Product change notification (PCN)

Title / short description	PSR-URM4 24V DC product adjustment
Affected article category	Functional safety
Change category	Marking, Documentation
Change number	CDN210122-01
Reason for PCN/PDN Revision	Adjustment of hardware revision due to internal correction

housing left (old)

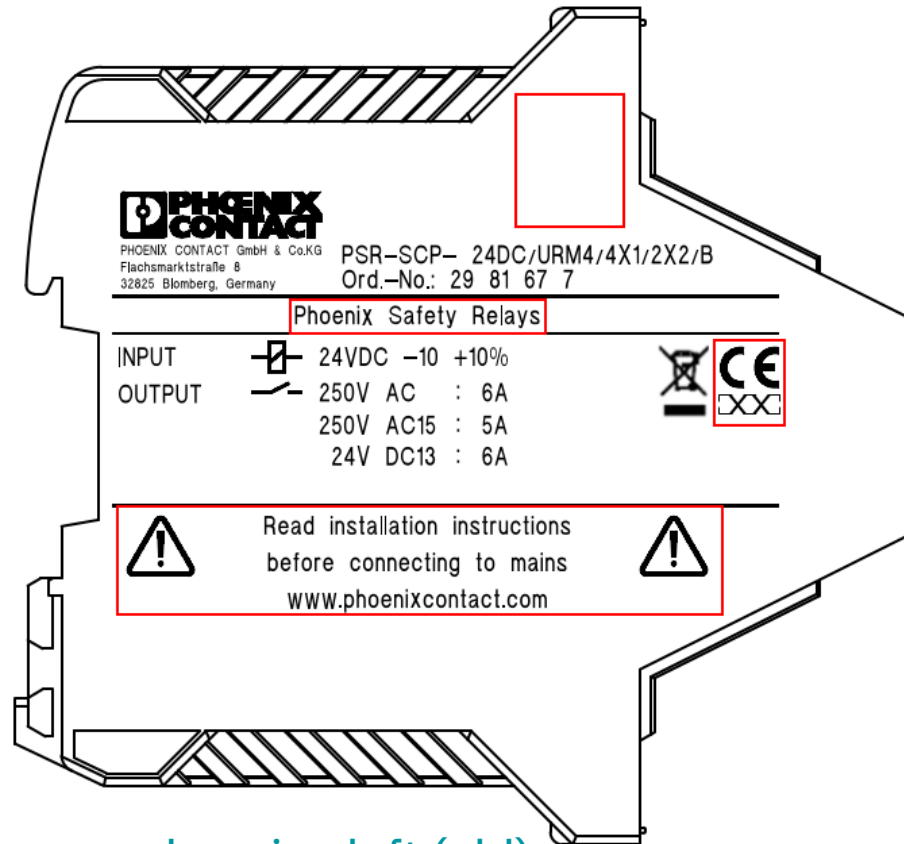
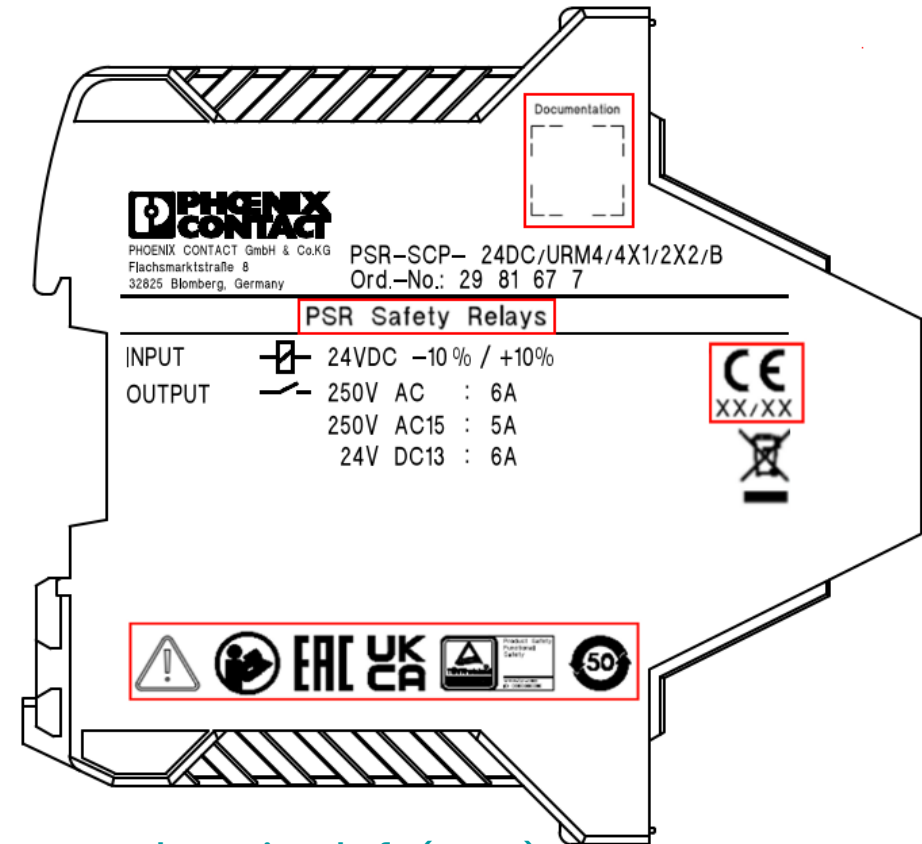
In addition to the year of manufacture, the calendar week will also be displayed below the CE mark. The various pictograms and TÜV approvals will be displayed in the lower area on the left half of the housing; the connectors will no longer be coded. New packaging dimensions are for item 2981680: 113 mm x 117 mm x 27 mm (L x W x H) and for item 2981677: 113 mm x 100 mm x 27 mm (L x W x H).
